DEVELOPMENT ASSESSMENT REPORT	
Application No.	DA/2022/0045
Address	39 Westbourne Street STANMORE NSW 2048
Proposal	Subdivision of the site into two (2) lots and construction of a semi-detached dwelling on each lot, with carport with first floor above at rear. Landscaping and associated works.
Date of Lodgement	30 January 2022
Applicant	PIENSA ARCHITECTS PTY LTD
Owner	Westbourne Holdings Group Pty Ltd
Number of Submissions	24
Value of works	\$754,050.00
Reason for determination at Planning Panel	Number of submissions
Main Issues	Solar access and overshadowing; submissions
Recommendation	Approved with Conditions
Attachment A	Recommended conditions of consent
Attachment B	Plans of proposed development

This report is an assessment of the application submitted to Council for subdivision of the site into two (2) Torrens title lots, construction of a semi-detached dwelling on each lot, with carport with first floor above at rear, landscaping, and associated works at 39 Westbourne Street, Stanmore.

Figure 3: Ground floor plan of proposed development showing location of principal living area and principal area of private open space.

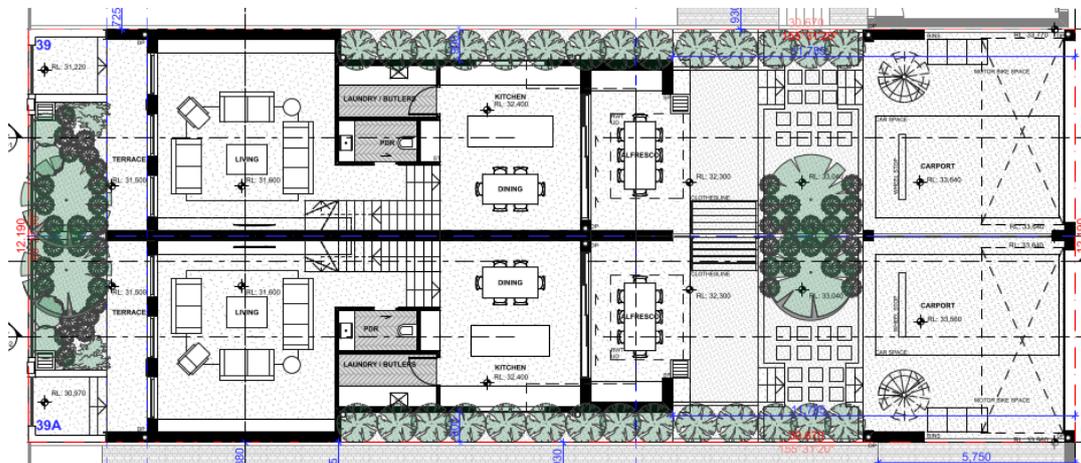
The windows of the principal living area of each dwelling will receive a minimum of 2 hours of direct solar access between 9.00am-3.00pm during midwinter. However, the orientation of the site makes compliance with C8(ii) difficult to achieve in this case.

Despite the site’s orientation, the proposed development has been appropriately designed to maximise direct solar access to the POS of each new dwelling.
